RIVERVIEW SUBDIVISION RESUBDIVISION OF LOT 13, REPLAT OF LOT 1

APPLICATION NUMBER 1 DATE February 7, 2019

REQUEST Subdivision

DETAIL SITE PLAN

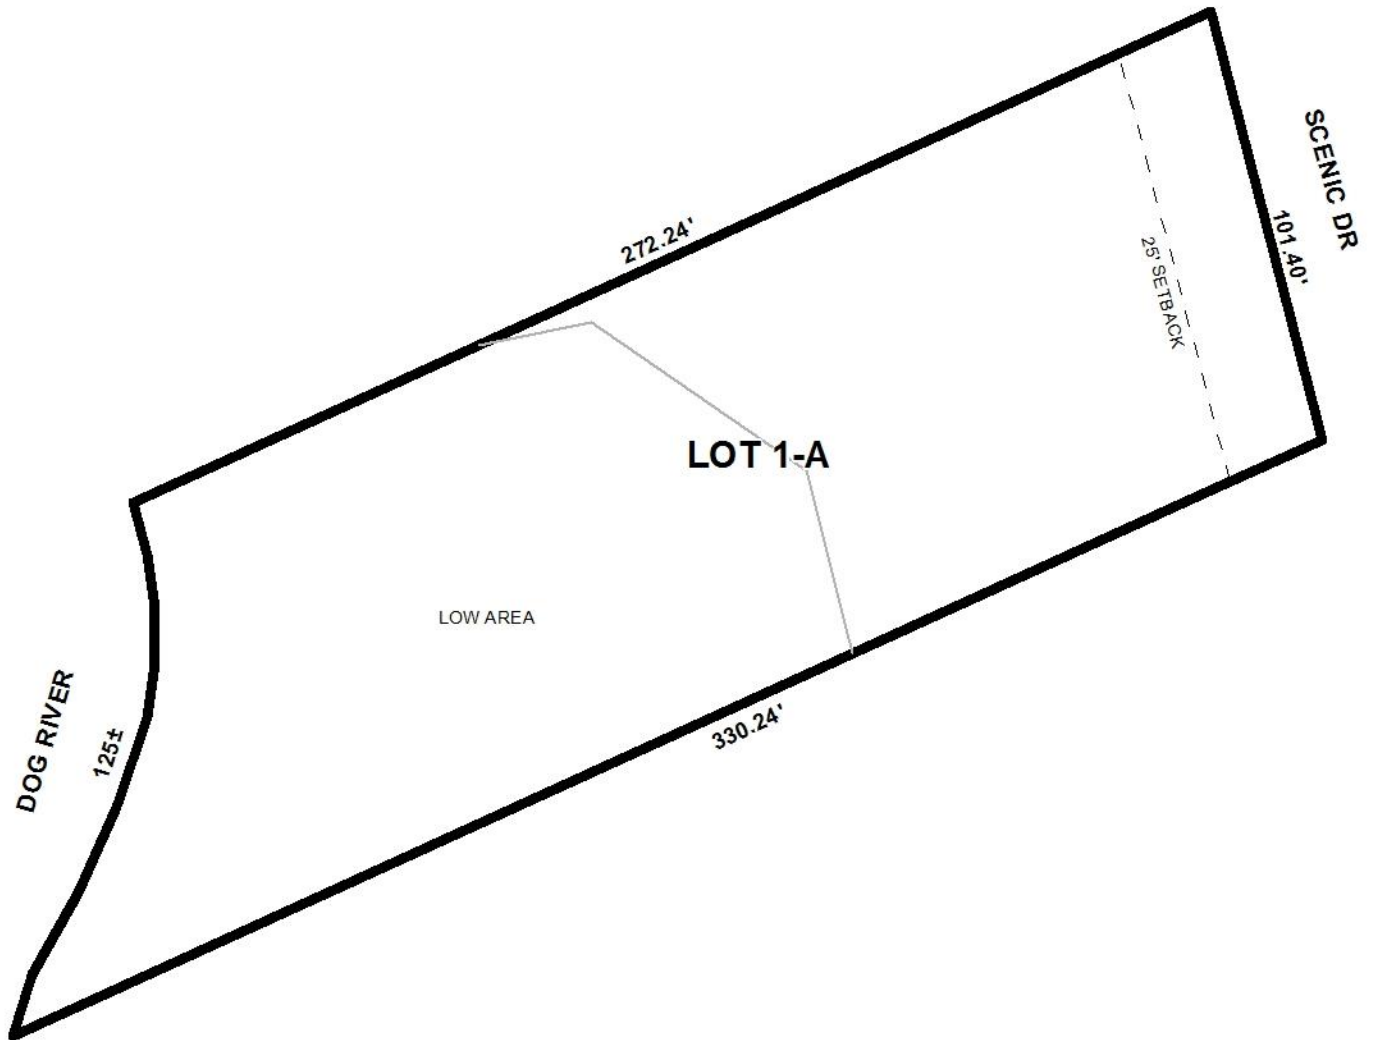
- B. Delete the note "25' ADDITIONAL R.O.W RESERVED FOR FUTURE PURCHASE BY CITY OF MOBILE..." from the FINAL PLAT.
- C. Show and label the existing ROW and the property that is being dedicated as Public ROW.

- D. Delete "LOW AREA (PER GIS)" or define in a note or LEGEND.
- E. National Wetlands Inventory (NWI) mapping, as shown on the City of Mobile GIS information, indicates that there is potential for wetlands within the property shown on this plat. Show and label the delineated wetlands, or provide a note stating that the wetlands shown on this plat are scaled from the NWI data and have not been delineated.

- F. Provide a note that a 25' riparian buffer may be required, during development, along the edge of anything considered by ADEM to be a water of the state.

- G. Show and label all flood zones. The proposed lot currently lies in an AE (el. 10) flood zone. The proposed "preliminary" FEMA maps (proposed to go into effect sometime in 2019) indicate that the flood zones located on this lot are proposed to be VE (el 14) and AE (el 11). For additional information go to <https://alabamaflood.com/map> or <https://maps.cityofmobile.org/arcgis/apps/webappviewer/index.html?id=29dd9da2bfa34338b884fc216ada0999&level=2>

- H. Show and label the MFFE (Minimum Finished Floor Elevation) on LOT 1-A.
- I. Provide the Surveyor's, Owner's (notarized), Planning Commission, and Traffic Engineering signatures.

The proposed lot fronts Scenic Drive, a minor street, requiring 50' right-of-way width. The preliminary plat illustrates a compliant 50' right-of-way width to Scenic Drive and, if approved, should be retained on the Final Plat. It should also be noted that the preliminary plat illustrates "5' additional right-of-way to be dedicated for future widening" which appears to be referencing the previous dedication, and should be removed as Scenic Drive has sufficient right-of-way.

A 25-foot minimum building setback line is depicted on the preliminary plat along Scenic Drive. If approved, the 25' front setback should be retained on the Final Plat.

The proposed lot exceeds the 7,200 square foot minimum lot size requirements for lots served by public water and sanitary sewer systems. The preliminary plat provides the lot size in square feet and acres. If approved, the lot size information should be retained on the Final Plat.

As a means of access management, a note should be placed on the Final Plat, if approved, stating that the lot is limited to one curb cut, with size, location and design to be approved by Traffic Engineering and conform to AASHTO standards.

- 1) Retention of the 50' right-of-way width along Scenic Drive;
- 2) Retention of the 25' minimum building setback along Scenic Drive;
- 3) Removal of the note regarding the 5' additional right-of-way dedication along Scenic Drive;

- 4) Retention of lot size information in both square feet and acres;
- 5) Placement of a note on the Final Plat stating the following Traffic Engineering comments: *"Driveway number, size, location and design to be approved by Traffic Engineering and conform to AASHTO standards."*;
